City of Binghamton
Water Street Development Corporation
Special Meeting
Wednesday April 12, 1:00 PM
Mayor's Conference Room, City Hall, 4th floor

RESOLUTION 23-6 A RESOLUTION OF THE CITY OF BINGHAMTON WATER STREET DEVELOPMENT CORPORATION TO ACCEPT A GARAUNTEED MAXIMUM PRICE OF \$22,060,245 FOR THE DEVELOPMENT OF THE PARKING GARAGE AND \$3,050,300 FOR THE SIXTH FLOOR PODIUM BY UNITED - PIKE DEVELOPMENT JV, LLC

City of Binghamton: Water Street Garage

Water St Municipal Parking Garage Contract Document List
4/5/2023

FP115

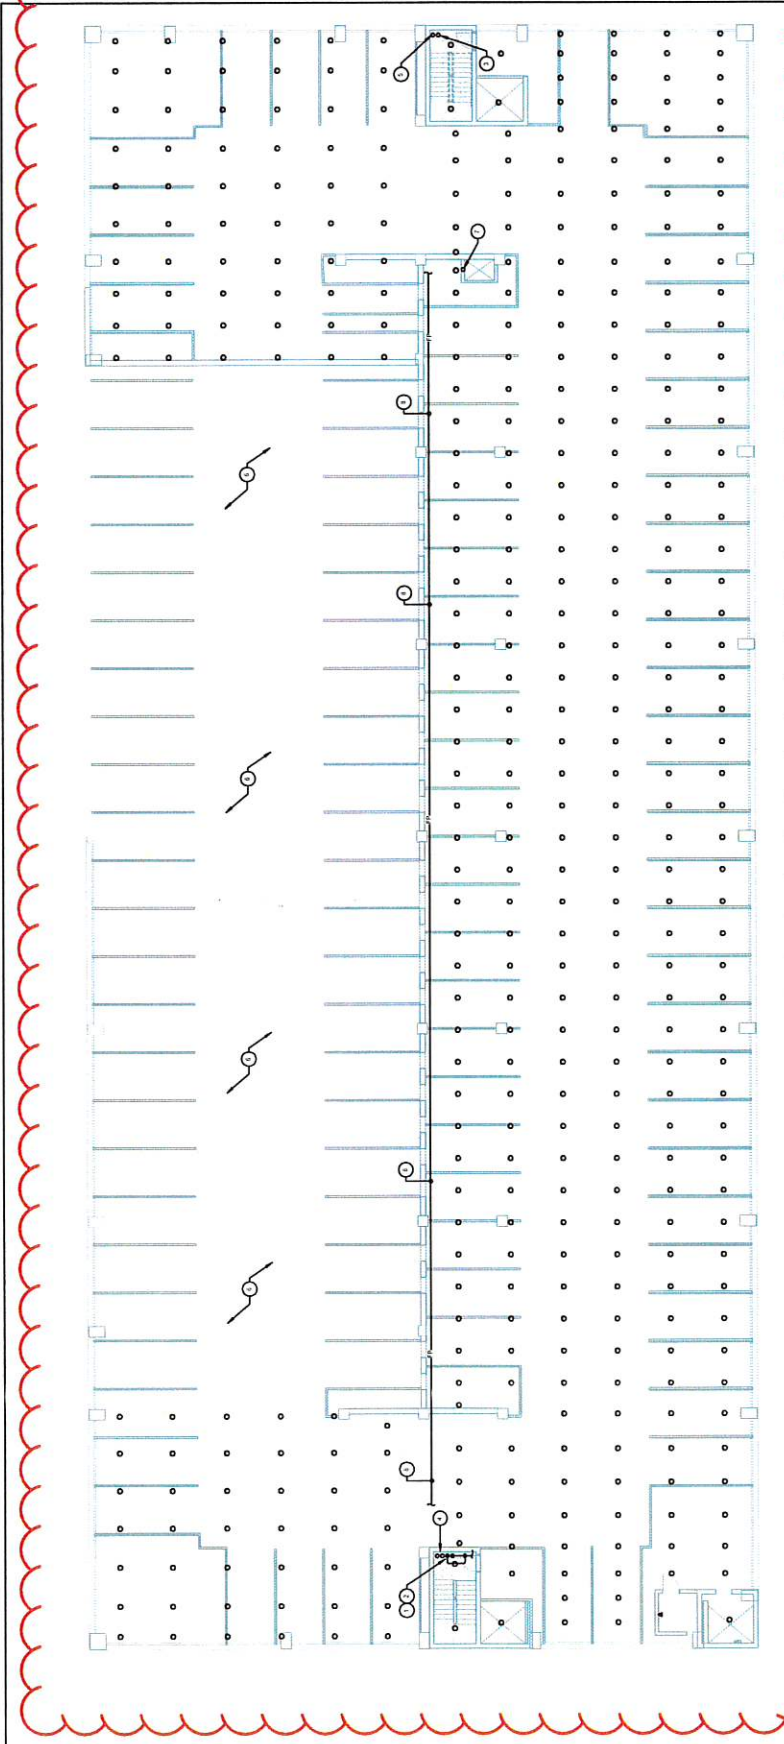
- *Installation of 5TH floor deck mounted lighting as shown on E-115. The intent would be to replace this lighting with pole mounted fixtures*
 - *Installation of the 5th floor fire protection system per as shown on FP115*

**ADD ALTERNATE
- FIRE PROTECTION COVERAGE OF 5TH FLOOR**

FP301

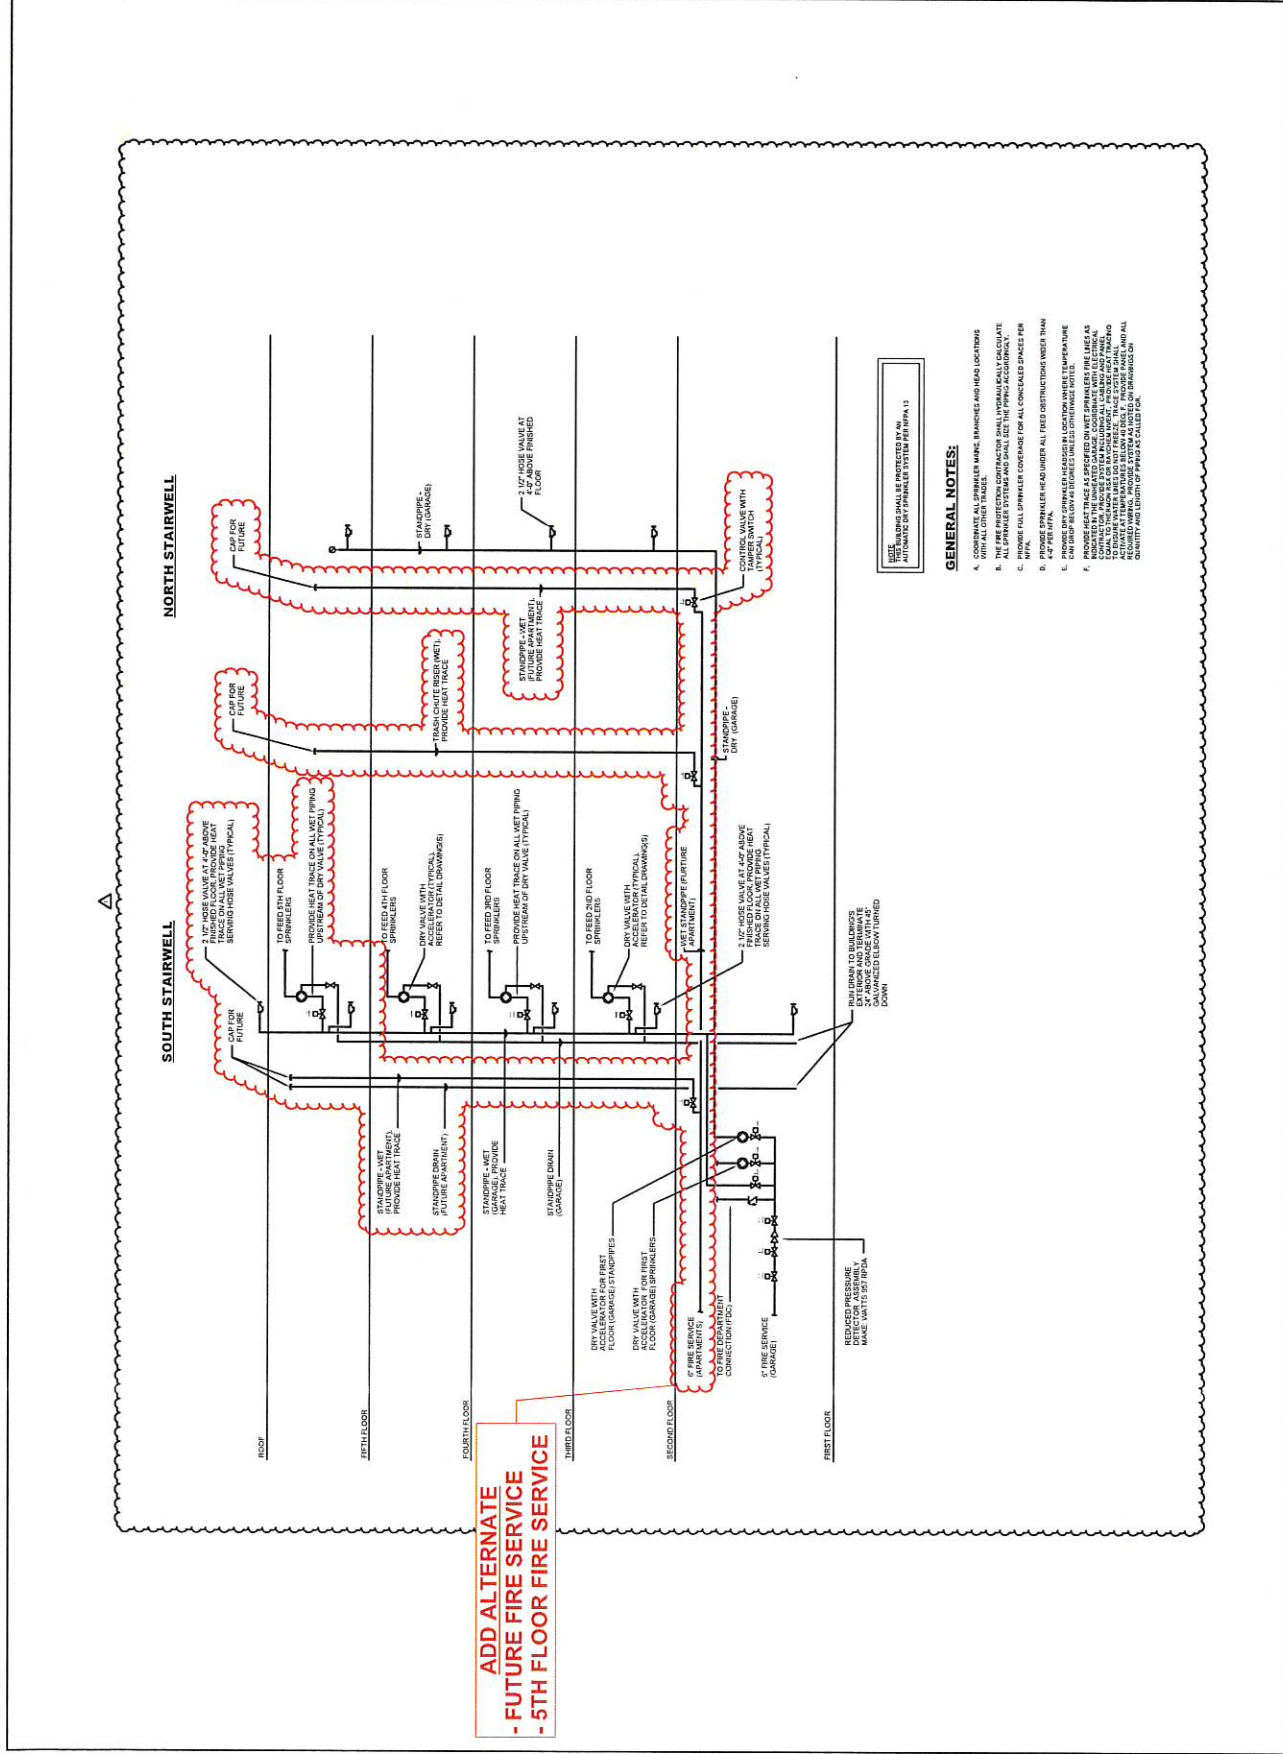
- *Installation of the fire protection service to future apartments on shown on FP301*
 - *Installation of the domestic water, storm and sanitary/waste and vent piping as shown on P111 through P115*

**ADD ALTERNATE
- FUTURE FIRE SERVICE
- 5TH FLOOR FIRE SERVICE**

DRAWING TITLE
PARKING GARAGE FIRST LEVEL PLAN

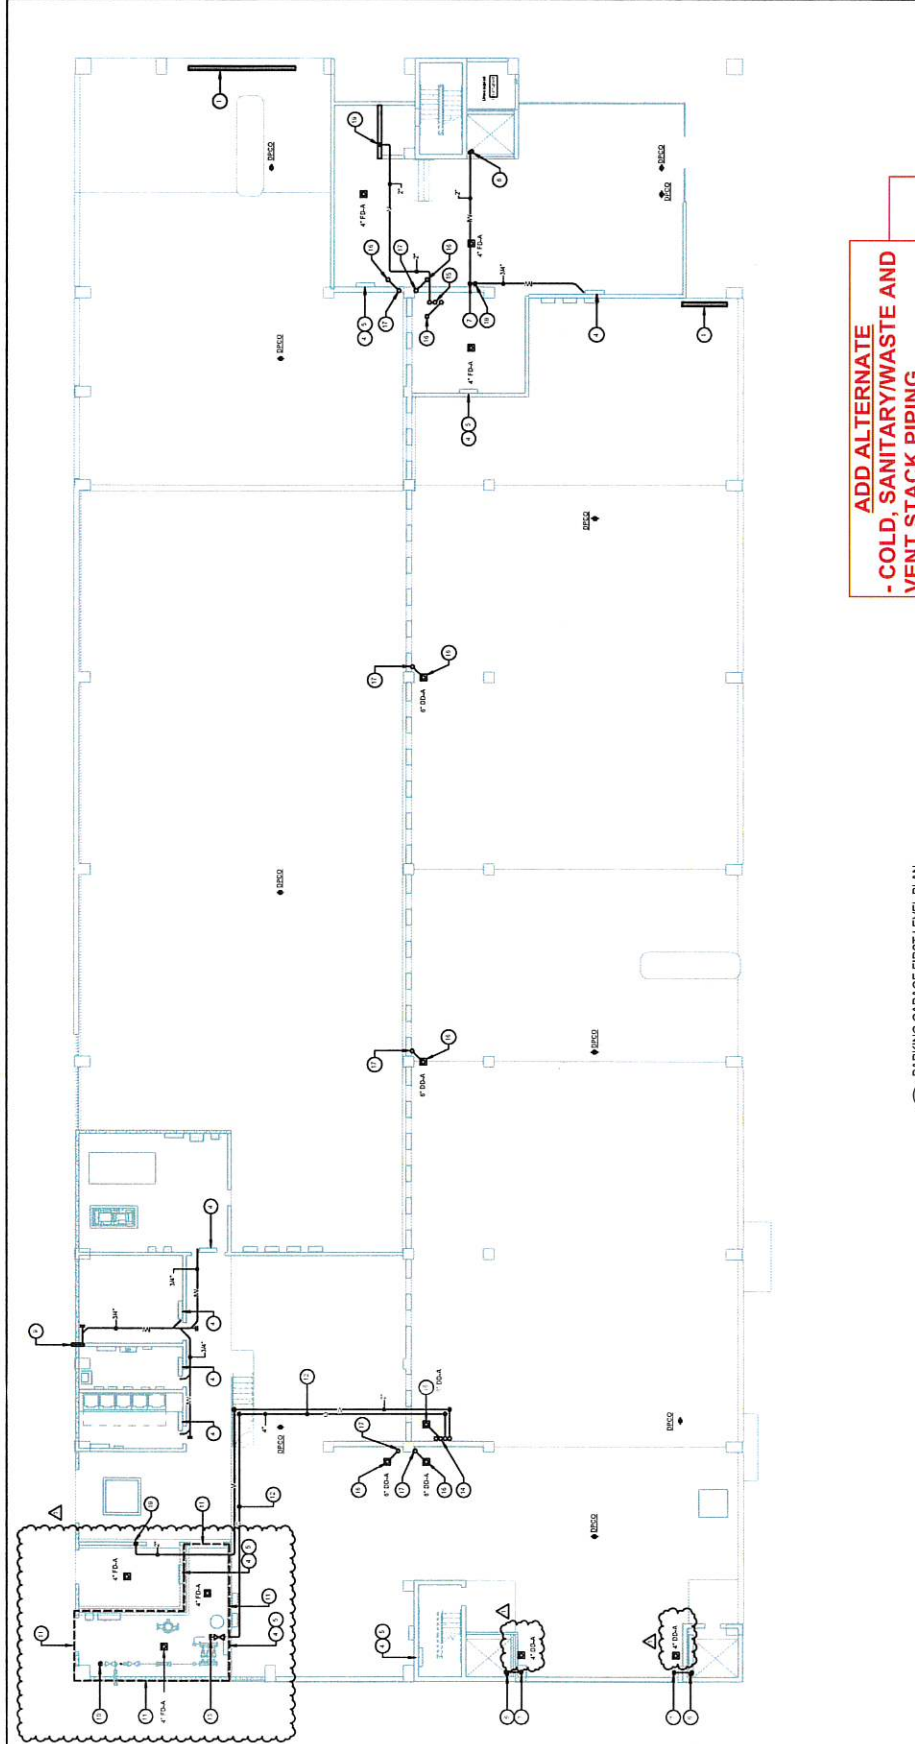
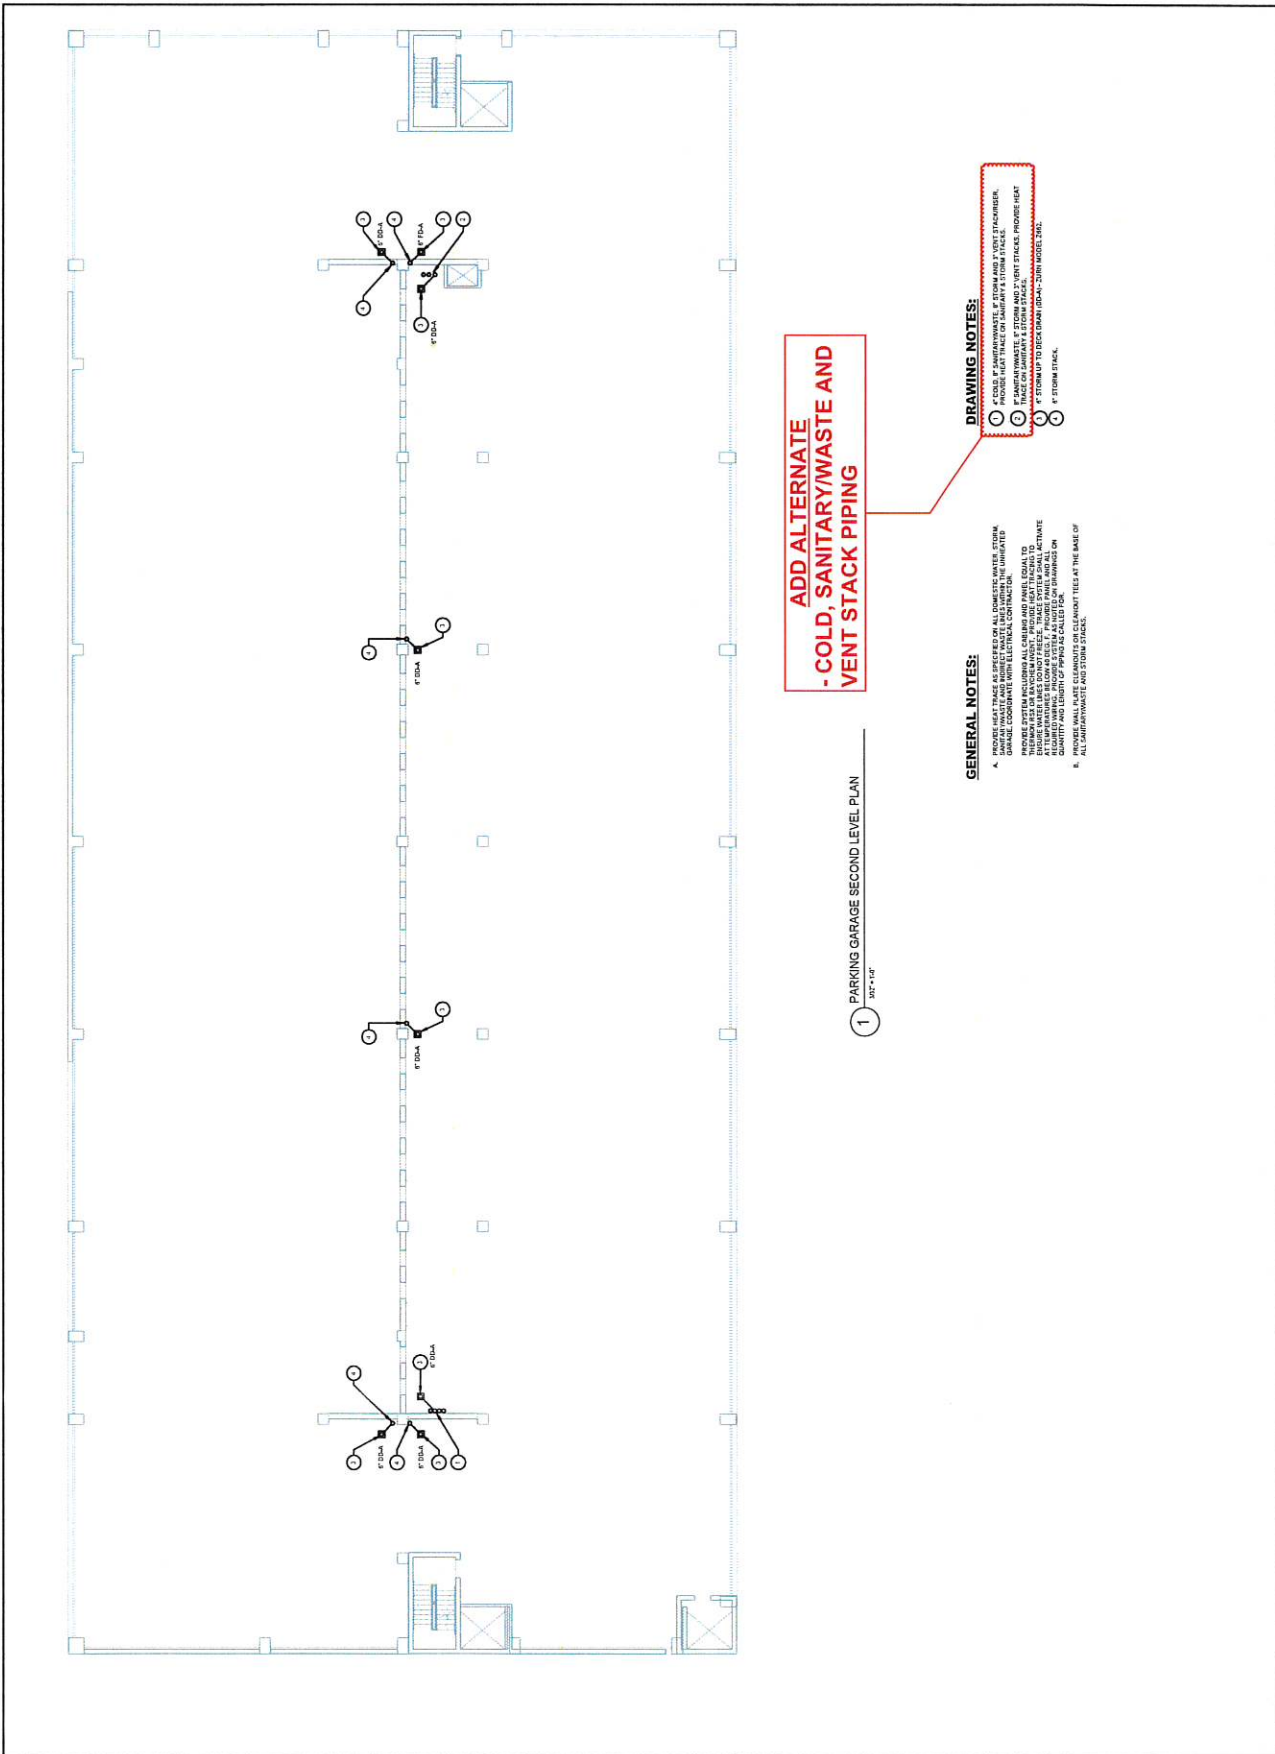
**ADD ALTERNATE
- COLD, SANITARY/WASTE AND
VENT STACK PIPING**

P113

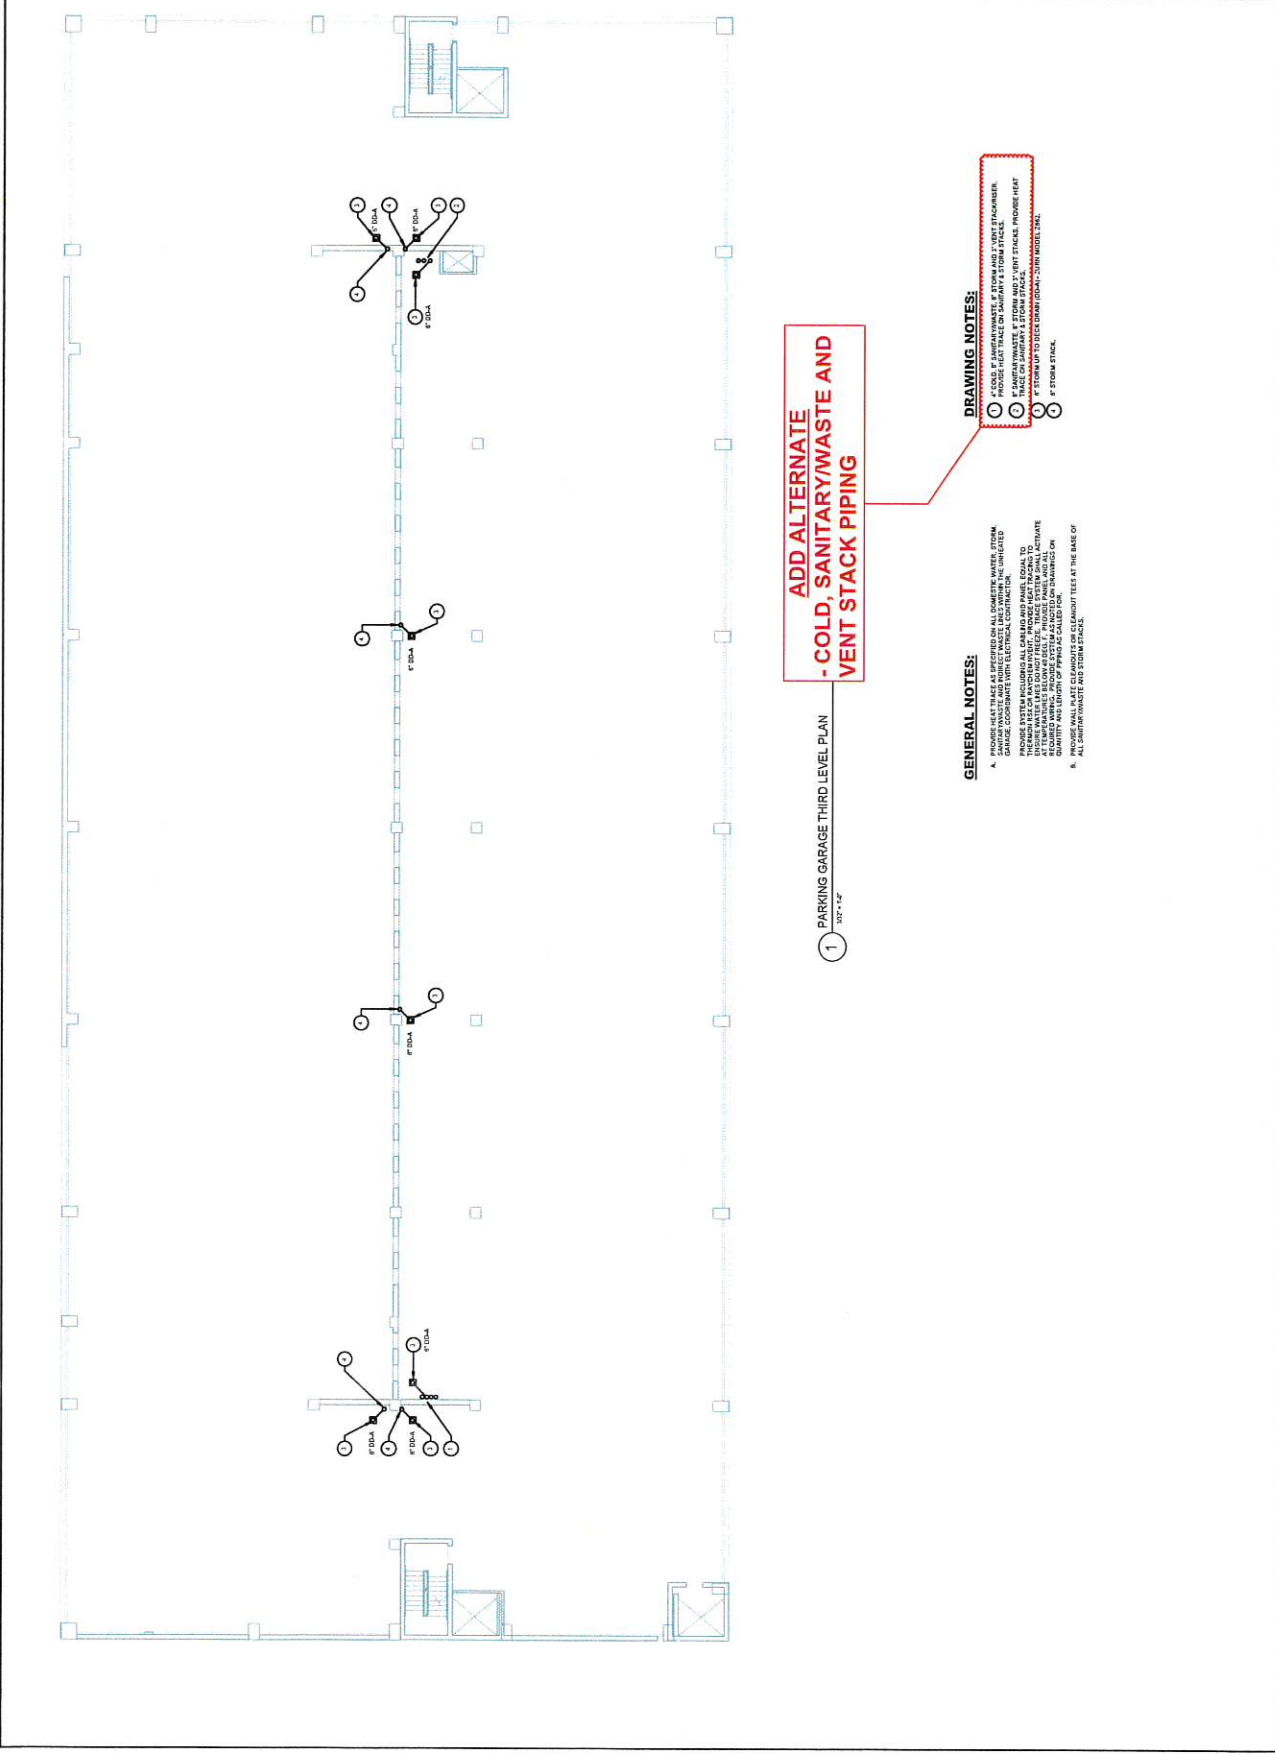
**ADD ALTERNATE
- COLD, SANITARY/WASTE AND
VENT STACK PIPING**
